April 11, 2013

SUBJECT: **Revision to On-hold Letter Response for Section 401 Water Quality Certification and Jordan Lake Watershed Riparian Buffer Authorization Application** for the replacement of Bridge No. 161 over North Prong Stinking Quarter Creek on SR 1124 (Stafford Mill Road), Alamance County, North Carolina. Federal Aid Project No. BRZ – 1124 (5), TIP No. B-4401.

**North Carolina Department of Transportation**  
**Highway Stormwater Program**  
**STORMWATER MANAGEMENT PLAN**  
 FOR LINEAR ROADWAY PROJECTS

Buffer Drawing  
 Sheet 2 of 5  
 Revised 4/8/2013

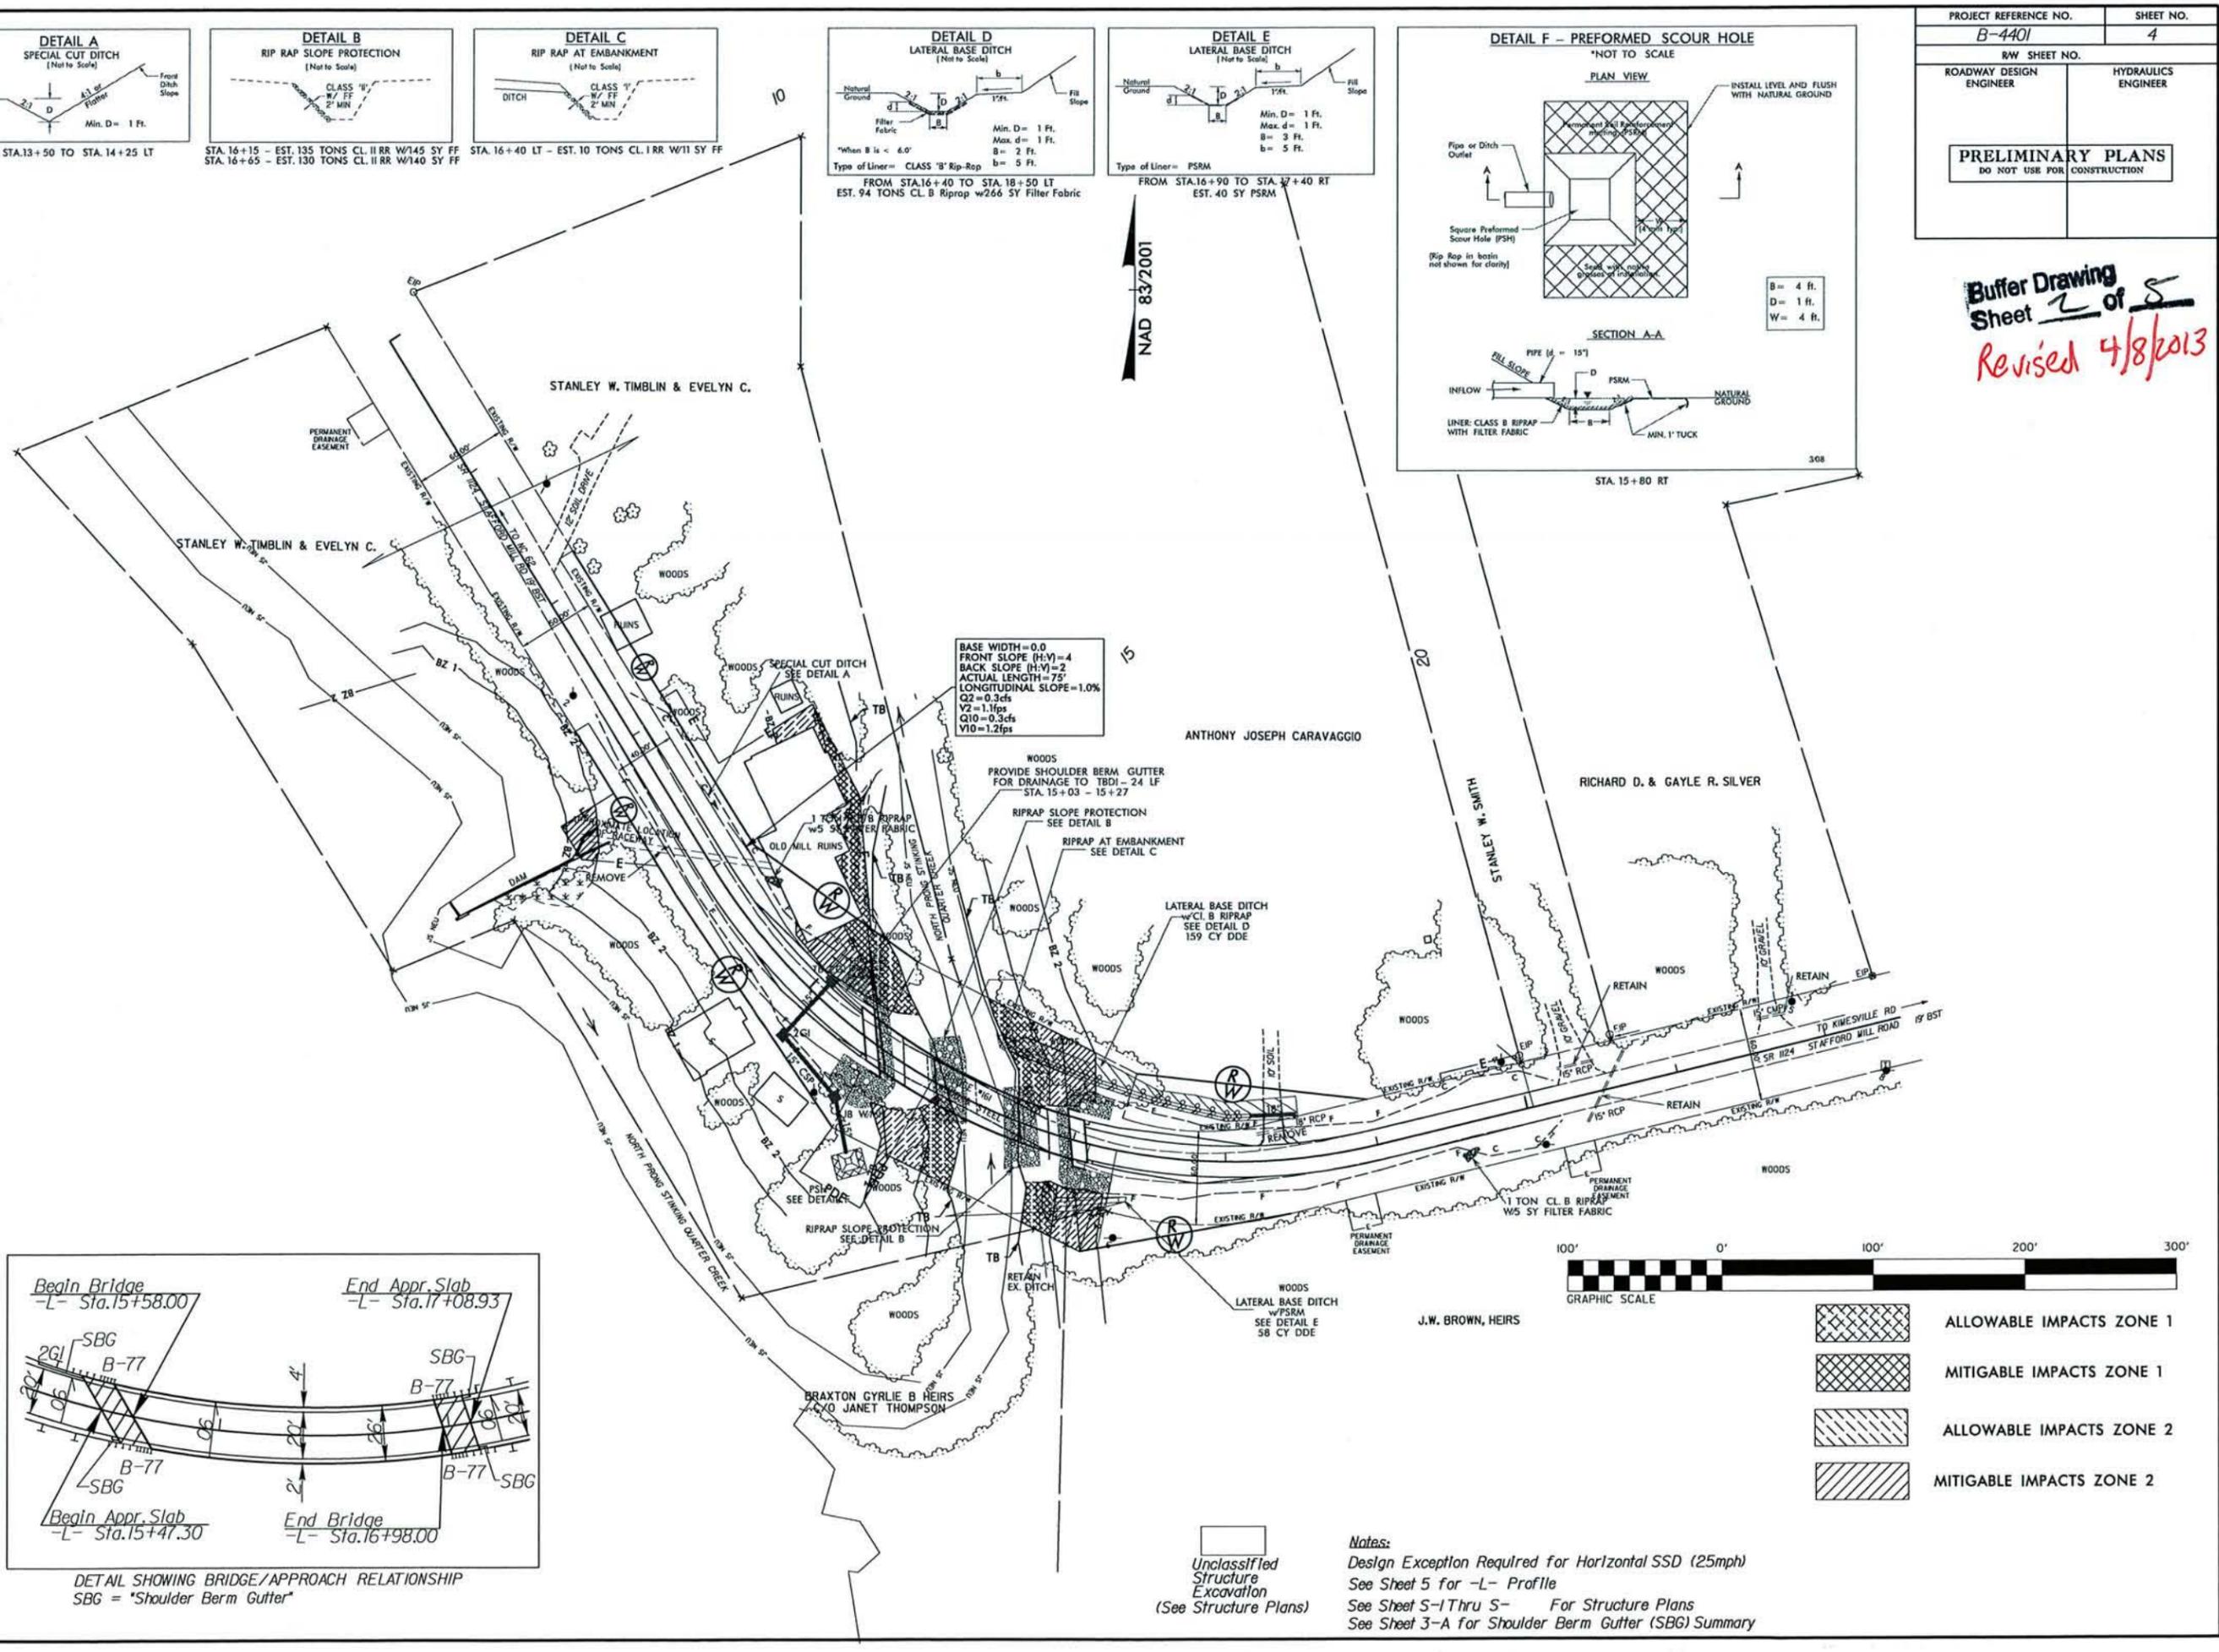
- The Stormwater Management Plan (SMP) has been updated to sufficiently discuss the stormwater design of the project and to provide additional information about both the existing and proposed stormwater ditches.
- The buffer drawings were revised because, after NCDWQ was supplied with complete information regarding the existing and proposed stormwater ditches, it was determined

that the buffer impacts resulting from the two proposed lateral base ditches should be considered "Allowable". Therefore, the portions of the ditches that run through the "Bridge" buffer impact zone were reverted back to being hatched "Allowable" and these impacts were listed separately on the Buffer Impact Summary Sheet. The impacts from the ditches where they run through the "Road Crossing" buffer impact zone are superseded by the "Mitigable" Road Crossing impacts; therefore, those impacts were included as Road Crossing and no ditch impacts are shown or calculated for those portions of the ditches.
